# Final Drainage Report

## Forest Heights Estates

**Project No. 2019.012**

PCD File No: MS206

Project Number: 18070  
Sheet: 1 of 1

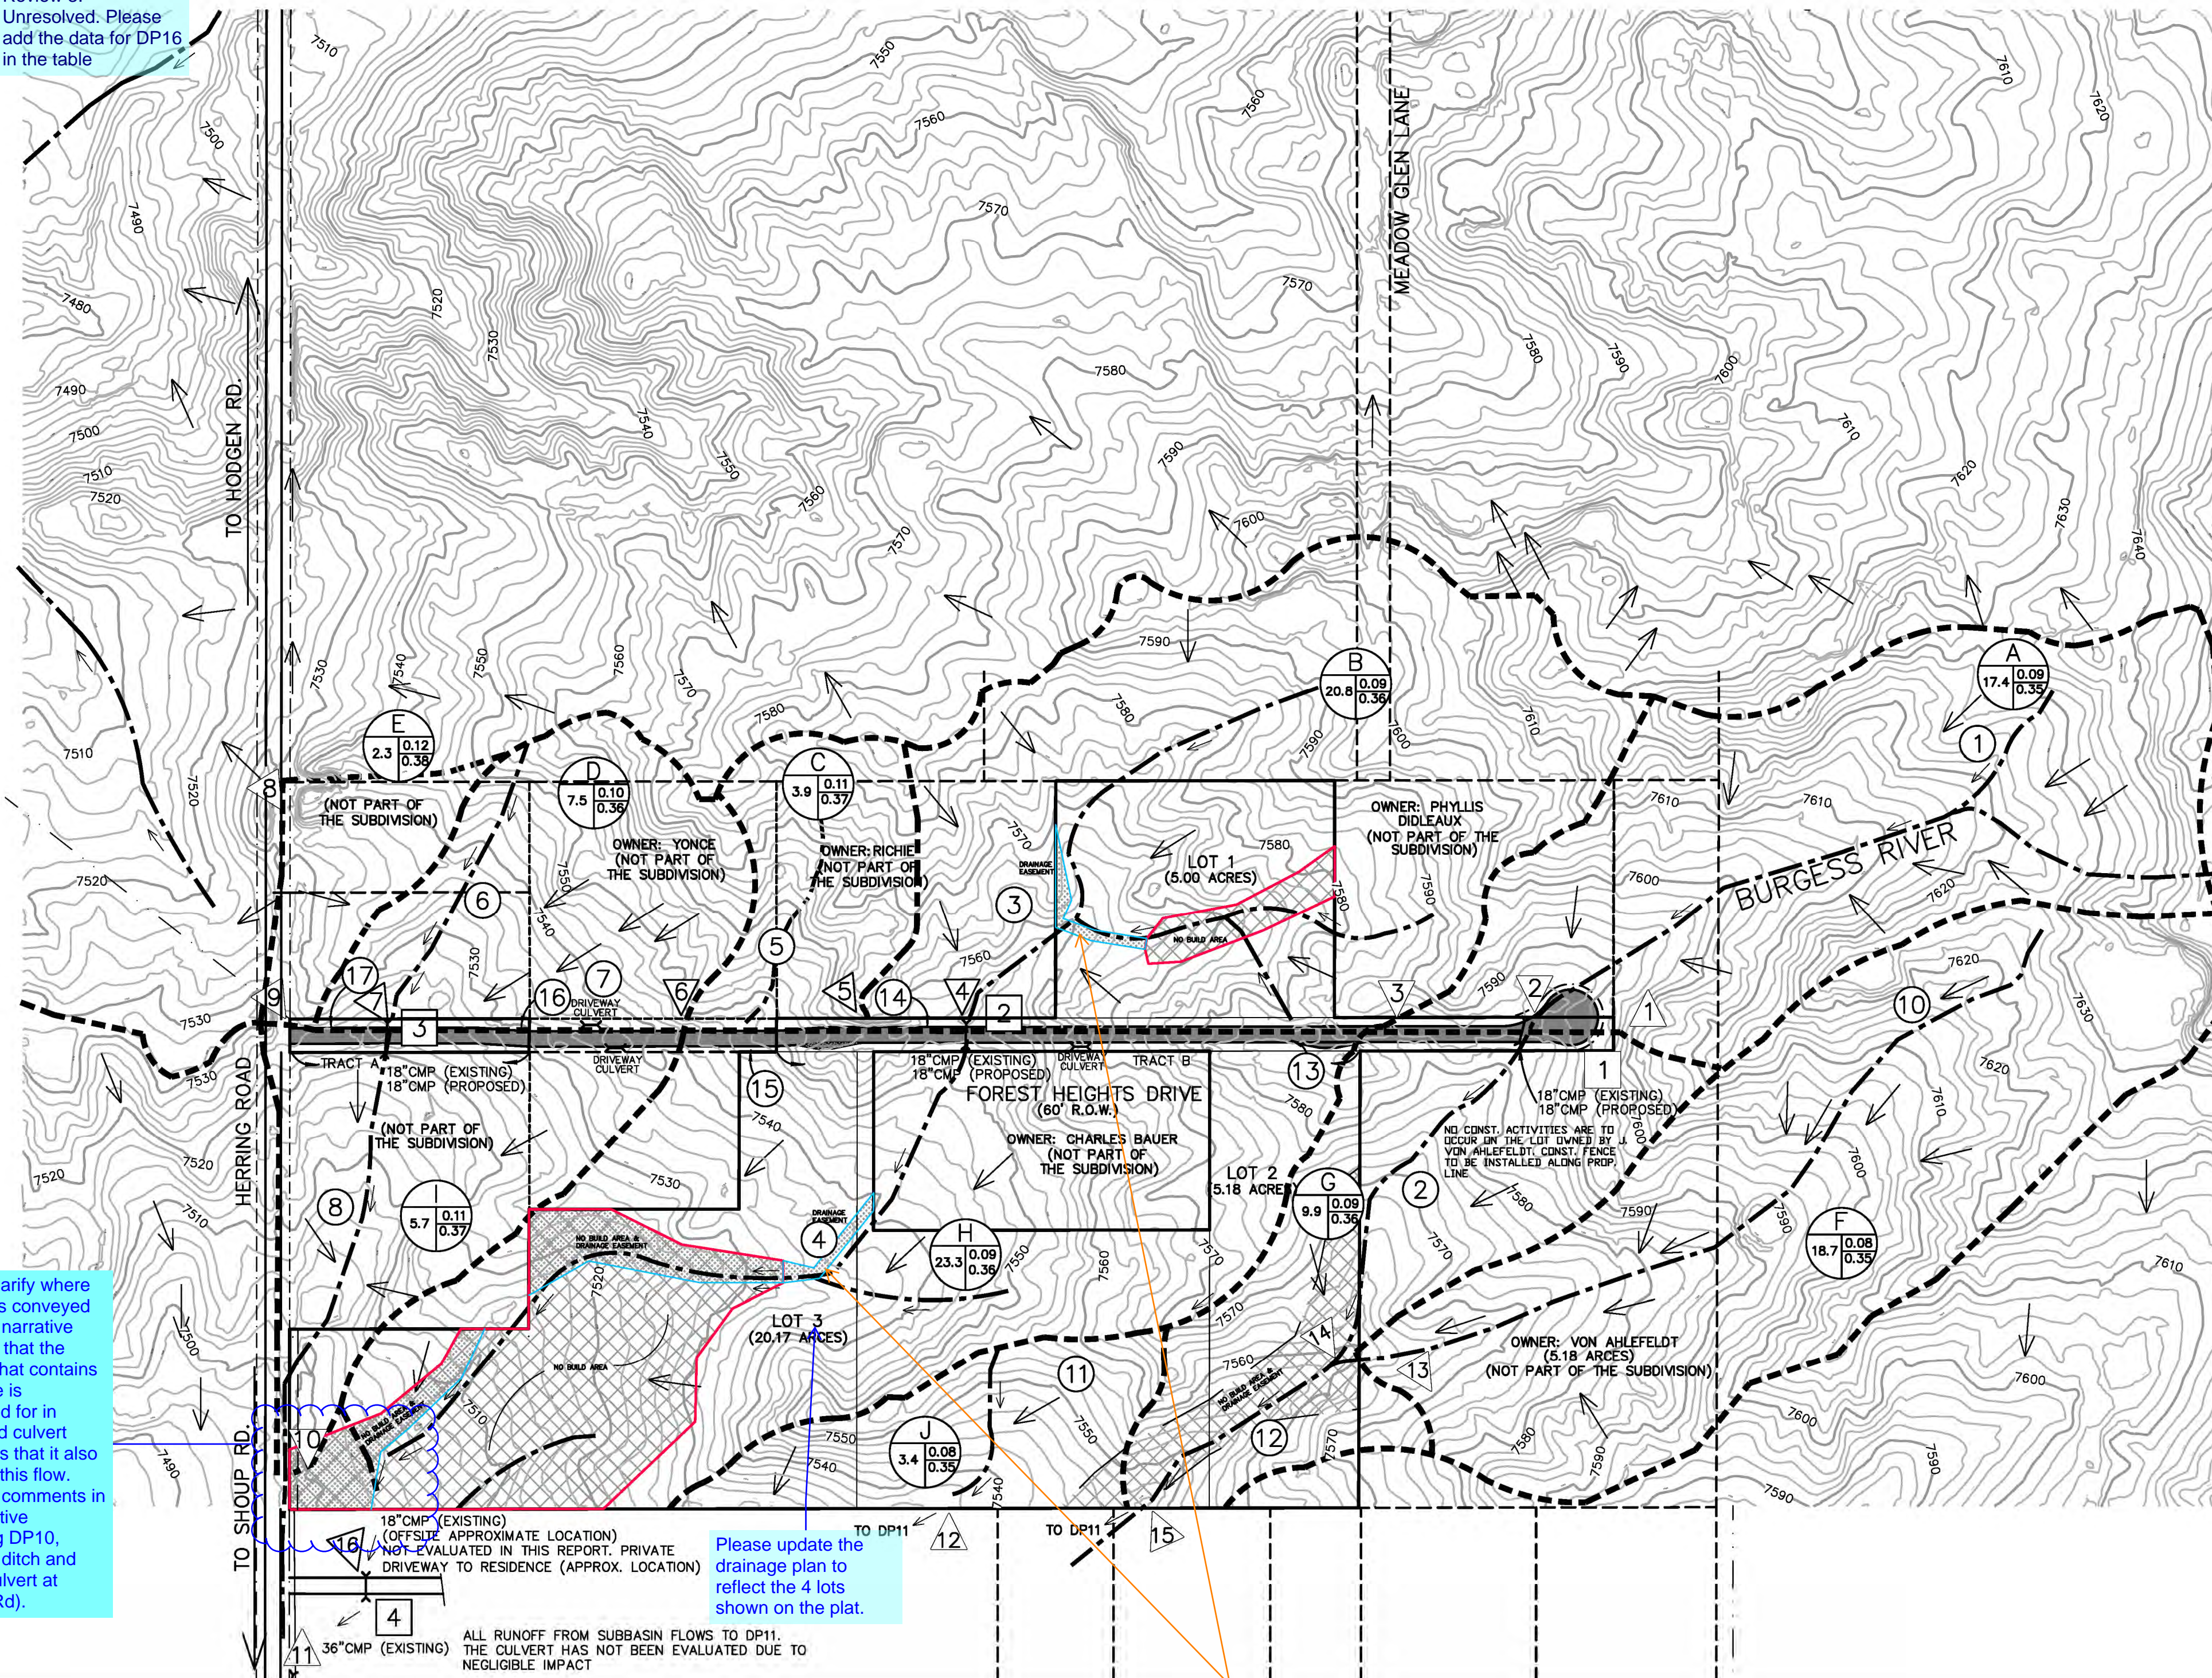
Review 2: DP16 data is missing. Please include  
Review 3: Unresolved. Please add the data for DP16 in the table
